REPORT AMENDED BY STAFF 4-27-89  
**CITY PLANNING COMMISSION**

- A. Negative Declaration
- B. Tentative Map to divide 15.5+ acres into one lot for 224 condominium air space units in the Multi-Family (Planned Unit Development) (R-2B(PUD)) zone
- C. Special Permit to develop 224 condominium air space units on 15.5+ vacant acres in the R-2B(PUD) zone

LOCATION: North of West El Camino Avenue between Gateway Oaks Drive and Natomas Main Drainage Canal.

# TENTATIVE SUBDIVISION MAP METRO CENTER PARCEL B CONDOMINIUMS

DRAWING NO. SITE PLAN

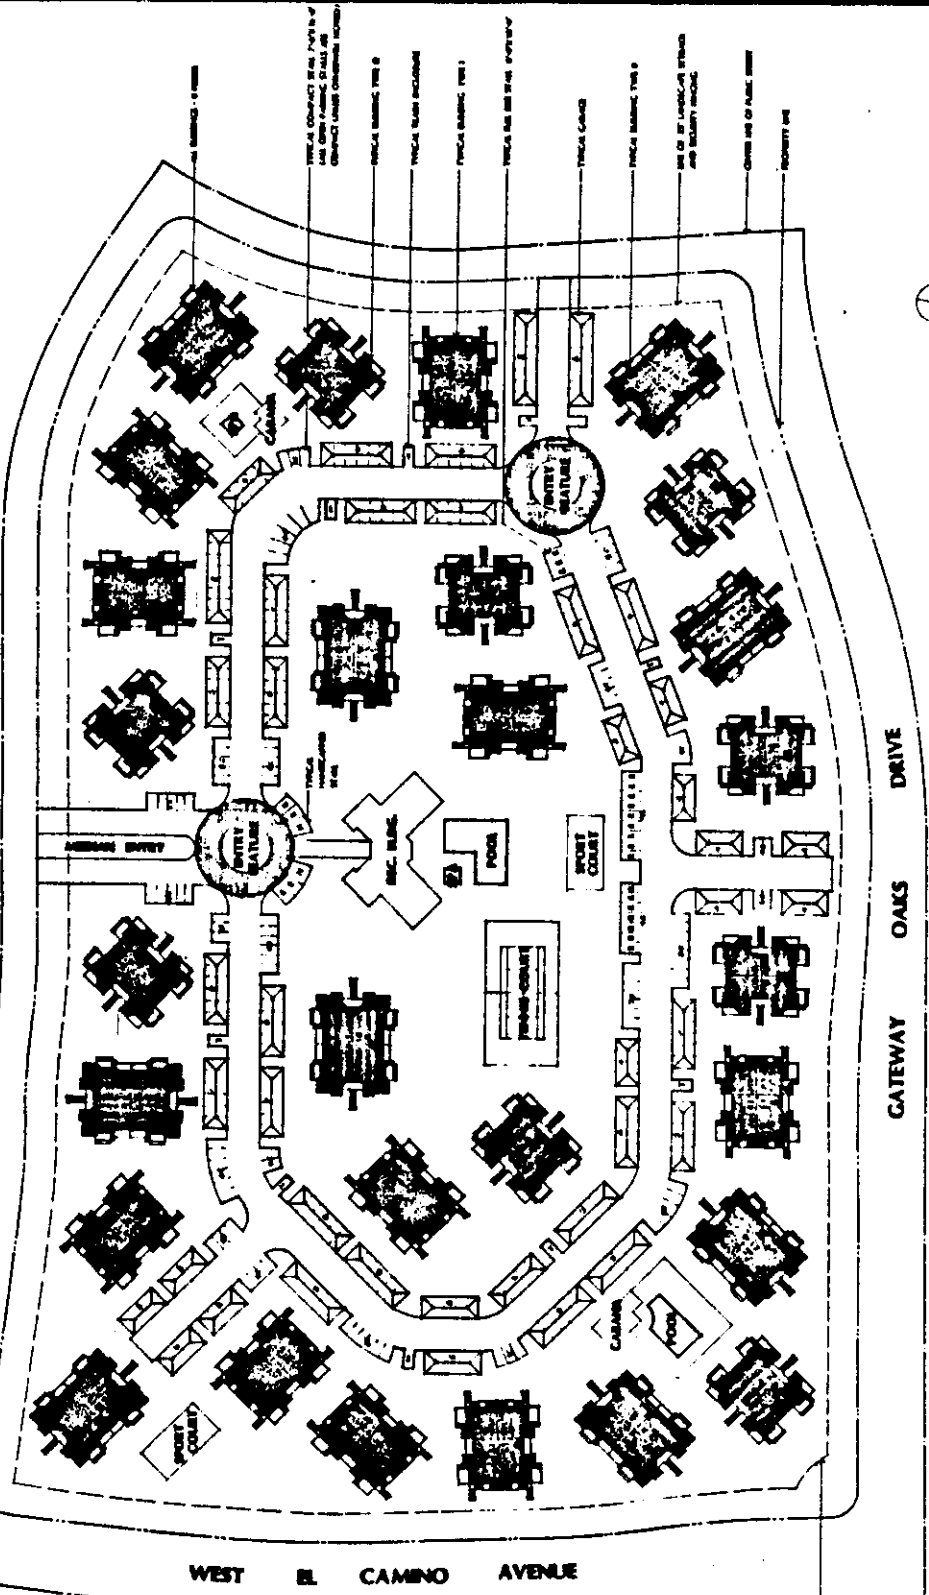
The submitted site plan indicates two median entrances off of proposed private streets. A 25' landscape setback with 3-1/2' undulating berms is proposed along the perimeter of the subject site. The site plan also indicates a perimeter fence with solid masonry wall panels around the entire site. Staff recommends that the applicant submit photos or drawings of the proposed wall and fence to the Planning Director for review and approval prior to issuance of building permits. A security gate and an entry feature is indicated at both entrances.

Indicated on the site plan is one resident and guest vehicular/pedestrian entry with a gate, and one resident only vehicular entry with a gate. Two pedestrian access gates off of Gateway Oaks Drive are proposed on the subject site. Staff was concerned with the monotony of straight building lines of all the enclosed garages indicated on the site plan. Staff recommends that some of the garages be recessed away from the private streets to allow landscaping to extend past the face of the garages. This will break up the monotony of the elevations facing the private roads.

The Zoning Ordinance requires 1.5 parking spaces per each unit and one guest space per every 10 units. A total of 351 parking spaces are required. The site plan indicates 224 covered garages, 25 open full size spaces and 102 open compact parking spaces. Sufficient parking will be provided on the subject site. In addition, the City's Traffic Engineer and Fire Department had no problems with the internal circulation and the ingress and egress on the site. No vehicles shall enter or exit off of Gateway Oaks Drive from the subject site. Sufficient handicap spaces shall be provided on the site.

1. A photo or drawing of the proposed wall along the perimeter of the subject site shall be submitted to staff for review and approval prior to issuance of building permits.
2. All trash enclosures shall comply with the City's Trash Enclosure Ordinance.
3. Mechanical equipment (including public utility boxes) shall be attractively screened.
4. The building shall contain at least three body colors to lessen potential monotony.

10. Handicap spaces shall be provided on the site and shall meet the building code requirements.
11. No vehicles shall enter or exit off of Gateway Oaks Drive.

**ELEVATIONS EXHIBIT D**

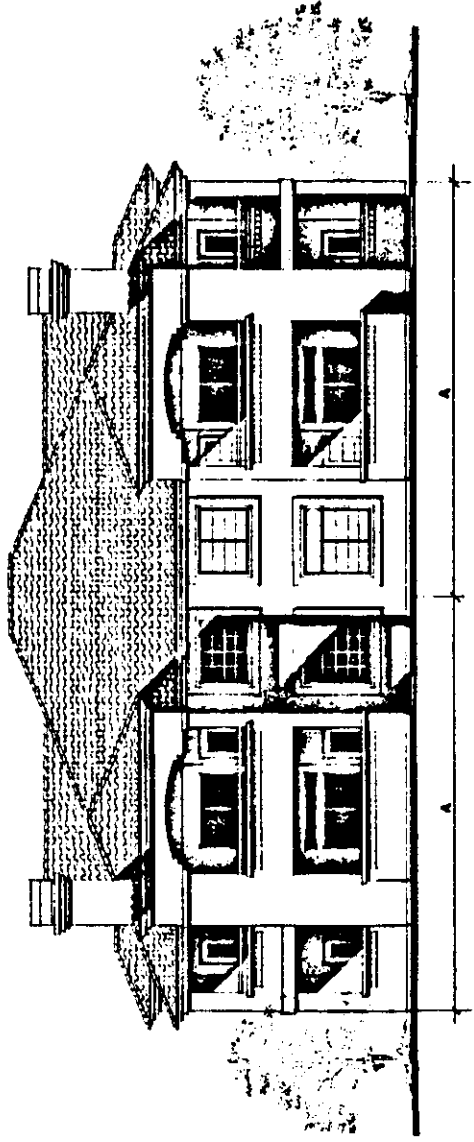
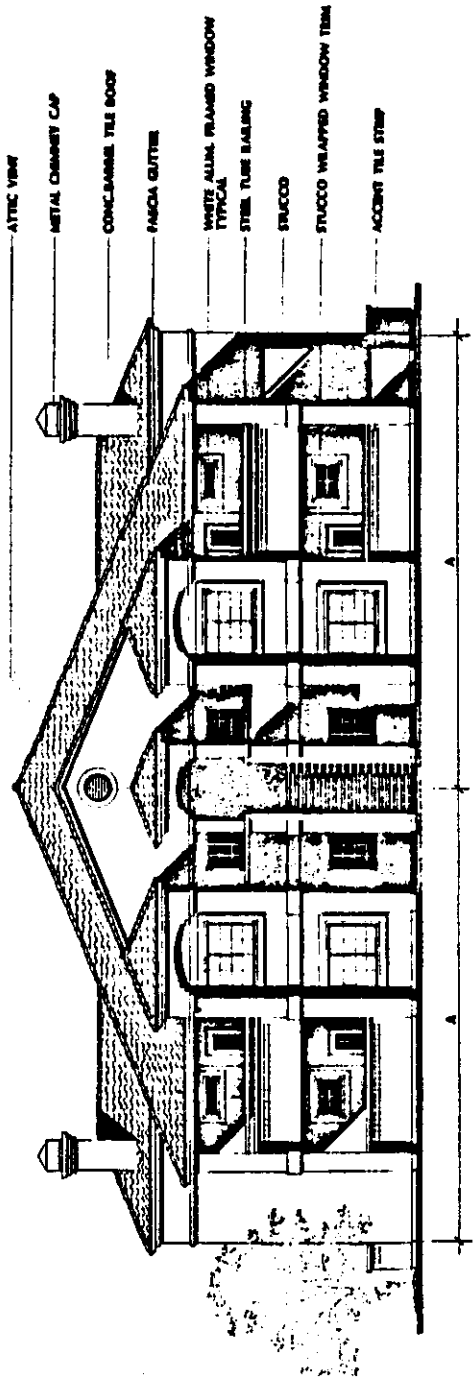
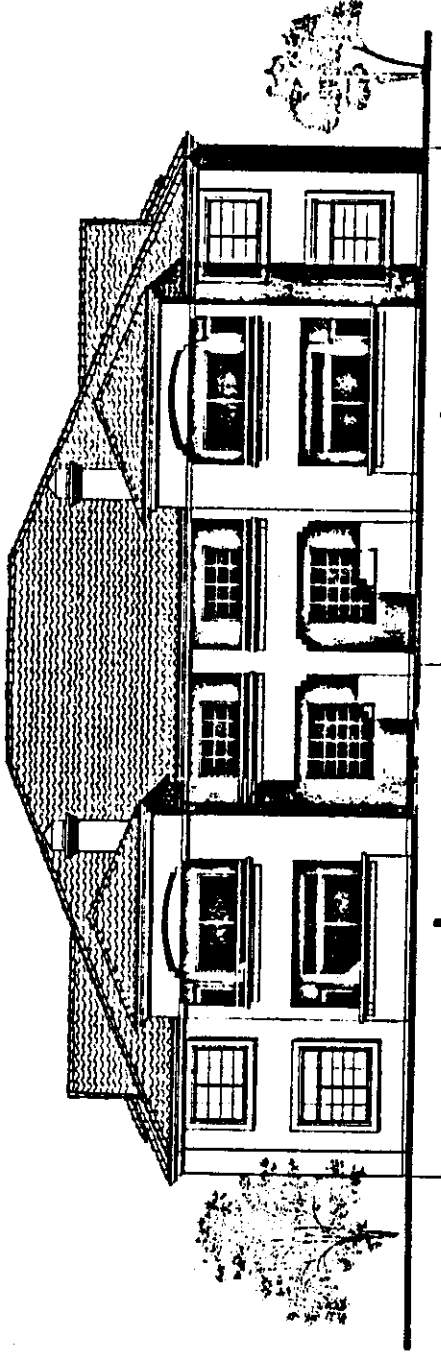
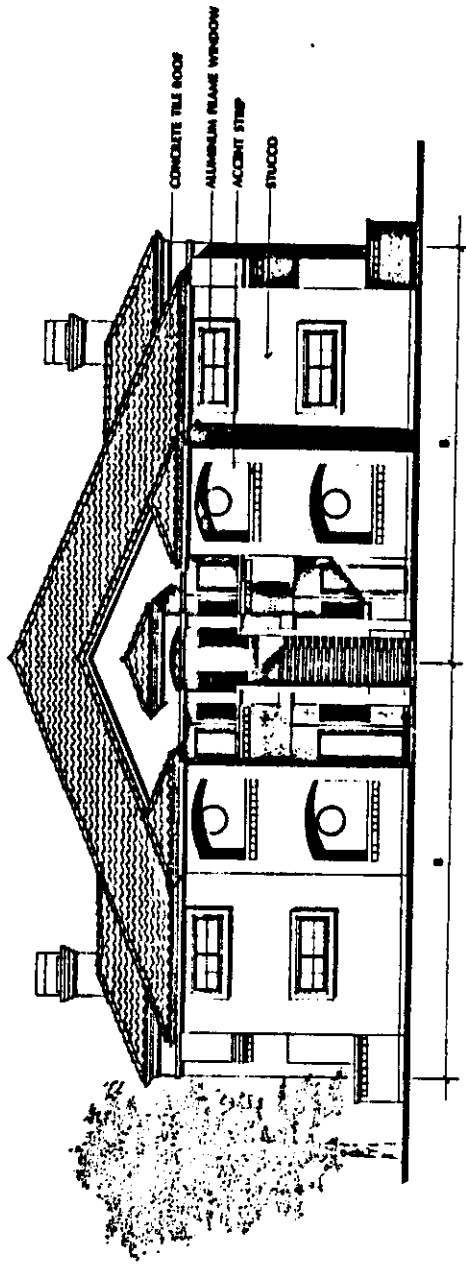
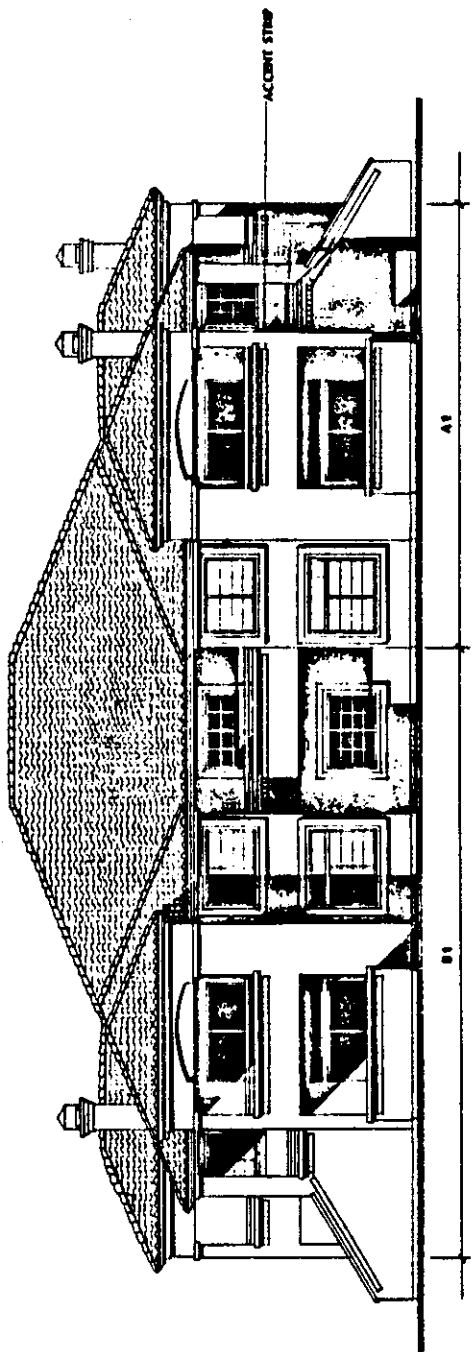
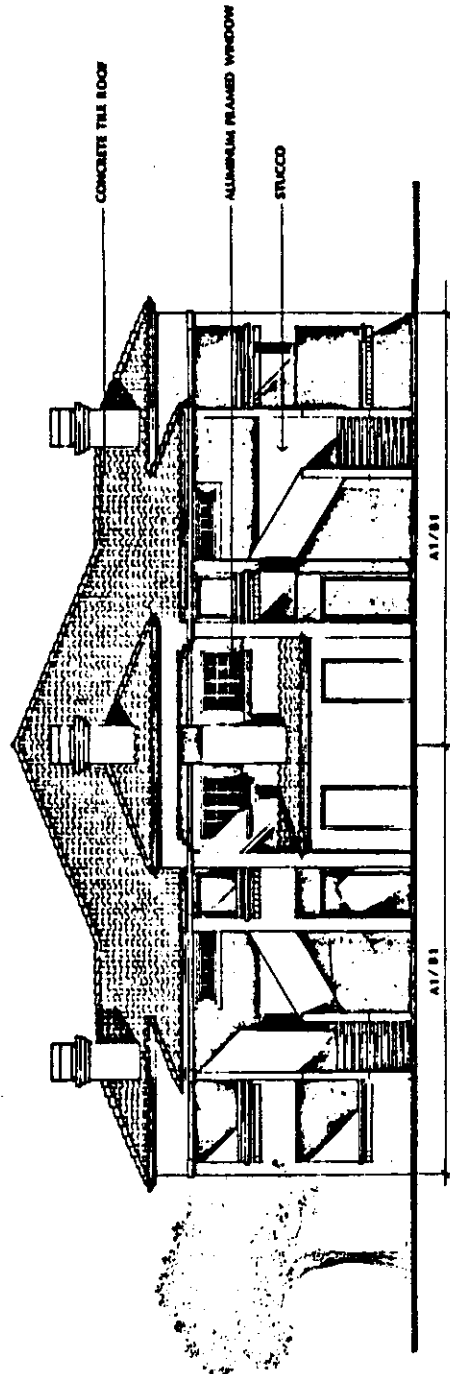
The exterior building material for the apartments consist of stucco plaster and the roof material is concrete tile. The building exterior color will be dusty rose, coral and off white colors with a light green trim. Staff recommends that the applicant vary the main body color. The elevations indicate white aluminum frame windows and an accent tile strip on some of the buildings. Staff recommends that all arches on the buildings be centered between column faces and the stepped spring line shall be symmetrical at each column.

8. All arches on the buildings shall be centered between column faces and the stepped spring line shall be symmetrical at each column *or other alternatives subject to staff approval. (staff amended)*

**JL CONSTRUCTION**  
**SACRAMENTO METRO CENTER AREA A**  
**CONCEPTUAL LANDSCAPE PLAN**

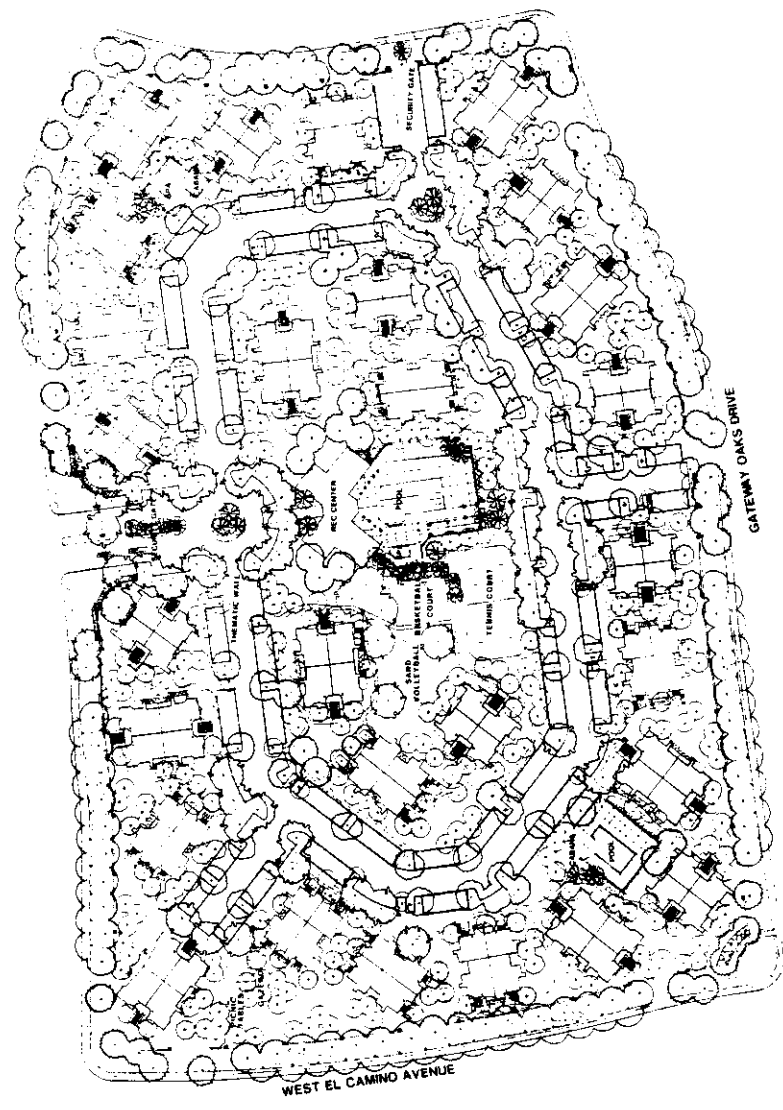
A landscape plan has been submitted. The landscape plan indicates a 25' landscape setback with 3-1/2' undulating berms. Staff recommends that the landscape treatment within the 25' setback area consist of lawn and trees. The minimum tree sizes shall vary (five and 15 gallon trees and 24 inch box trees) along the perimeter. The landscaping shall be complementary to the building design and architectural theme. The applicant will be required to meet the 50% shading requirement for all surface parking areas. Sufficient landscaping is provided throughout the site.

9. The landscape treatment with the 25' setback shall consist of lawn and trees varying in minimum sizes of five and fifteen gallon trees and 24 inch box trees.
